Delegated Report

Planning Application Nos: 20251249 (Planning) and 20251250 (Listed Building)

Location: Boughurst Farm, Leywood Road, Meopham, Gravesend

Description: **20251249:** Demolition of porch and erection of a two storey rear extension plus internal alterations to include structural alterations to link the new extension, internal reordering to the ground and first floor, new and replacement windows and associated hard landscaping.

Existing north elevation:

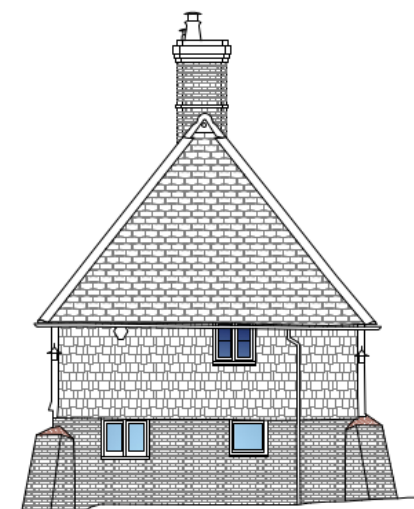
The current proposed 38% increase in the floor area of the existing dwelling is over the one third limit set out in Policy C13 and would increase the mass of the dwelling from the side:

However, it must be recognised that the house has not had any previous extensions and due to the location of the proposed extension to the rear and northern end of the house, which will keep the principal elevation intact, and the fact that it will be separated by a subordinate link and lower ridge, a 38% increase in floor area is not considered to be significantly over the extension limit, and therefore is not considered a disproportionate addition.

On this basis, the proposed extension would comply with the requirements of saved Policy C13 of the Local Plan 1994 and would not result in a disproportionate addition, which would mean the proposal is not inappropriate in the Green Belt and would comply with paragraph 154c of the NPPF 2024.
